Re: 23-28 Creek Drive LLC
City of Beacon, New York
MC Project No. 14000477B

We have received the comments on the Traffic Impact Study for the 23-28 Creek Drive development as presented by Creighton Manning in their April 4, 2019 letter to the Planning Board. The following provides specific responses to each of the comments presented in that letter.

Site Plan

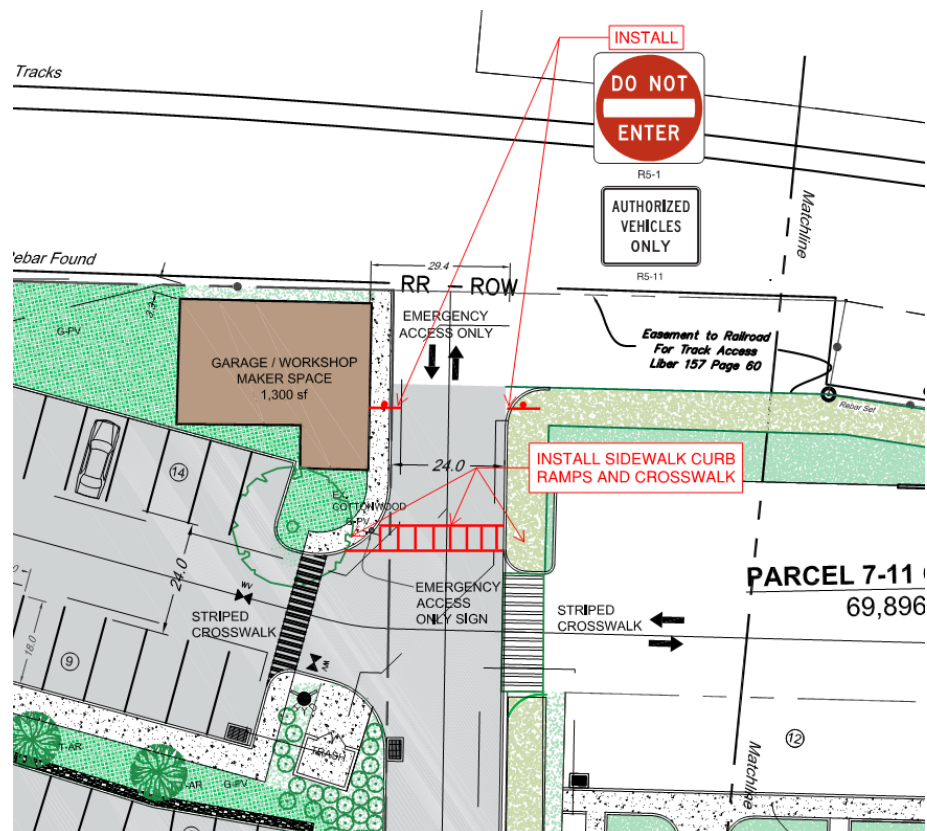
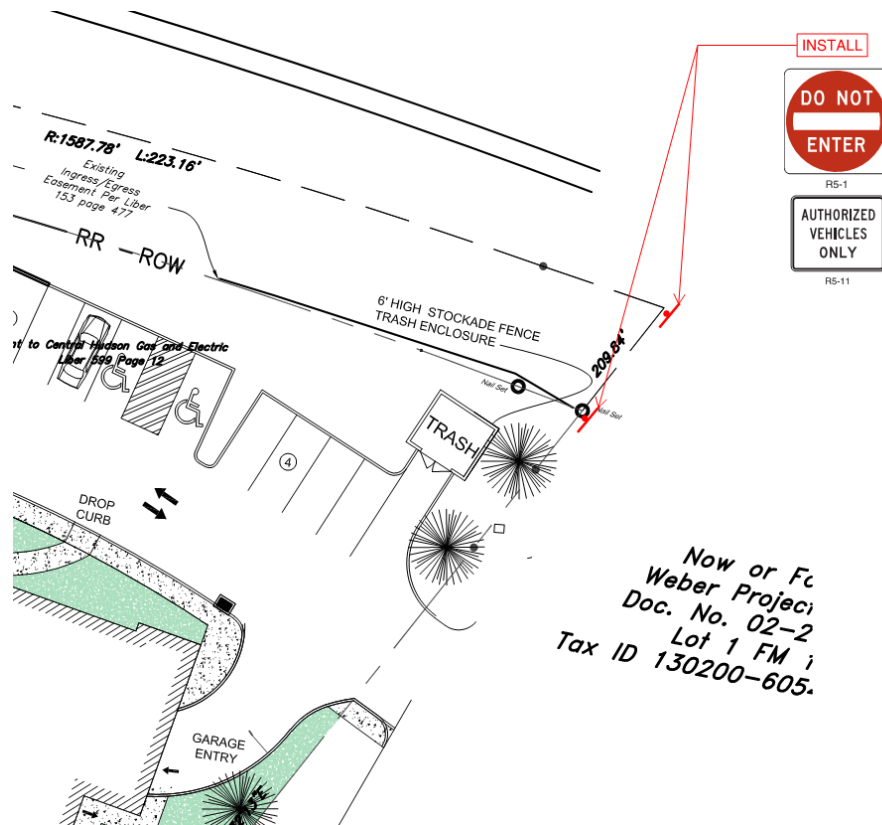
1. CM recommends that the applicant consider adding crosswalks and ramps at the internal intersection between 7-11 Creek Drive and 23-28 Creek Drive to enhance pedestrian connectivity between buildings, as shown below:

2. CM recommends additional traffic control signs, markings, and/or other physical features to reduce the likelihood that Creek Drive is used for non-emergency access. Consideration should be given to both ends of Creek Drive so that the intended purpose of the road is clear to arriving and departing traffic, especially visitors who will not gain a sense of familiarity with the property. CM notes that Google Maps directs inbound traffic to 23 Creek Drive onto Creek Drive from Churchill Street, which is not the intended circulation. Maser should assess and provide specific recommendations.

Response: Comment noted. A crosswalk and sidewalk curb ramps will be added on the west side of the intersection. A crosswalk on the east side would lead to the proposed trash enclosure for 23-28 Creek Drive and therefore does not seem to be an appropriate location for a crosswalk. See exhibits in Item No. 2 below for proposed location of this crosswalk.

Response: *“Do Not Enter” signs should be placed at the Creek Drive intersection with Churchill Street as well as the emergency access intersection with Creek Drive to designate to drivers that Creek Drive is not open to regular traffic. These signs could also be supplemented with “Authorized Vehicles Only” signs (MUTCD NO. R5-11). If desired by the City, further enforcement of the nature of this access could be implemented such as the installation of bollards or a gate that would be accessible by emergency vehicles only but would still permit pedestrian flow. The proposed signing is shown in the below exhibits.*
